Healthcare Interpretations Task Force – Interpretations Issued
Compiled by Gene Cable, officially reported by NFPA and ASHE Web sites

December 7, 2009

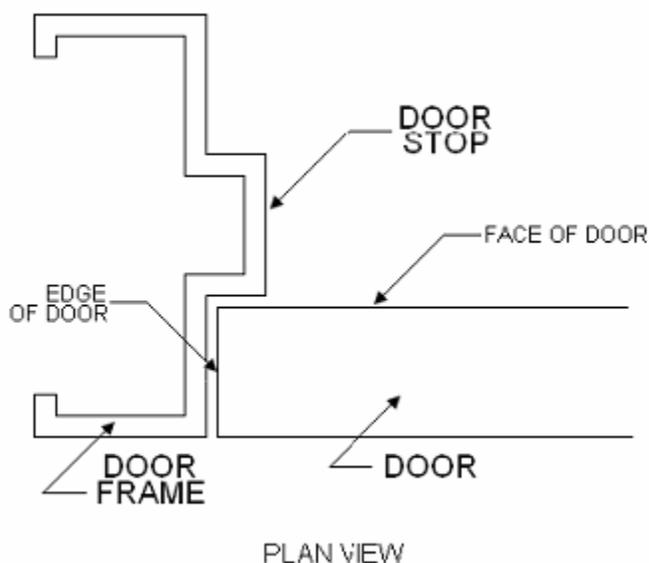
Question 3: Does the Life Safety Code limit the gap between the meeting edges of the leaves of a two-leaf corridor door to 1/8-inch?

Answer 3: **NO.** The gap is permitted to exceed 1/8-inch provided that the meeting edges of the leaves are equipped with an astragal, a rabbet, or a bevel.
HITF
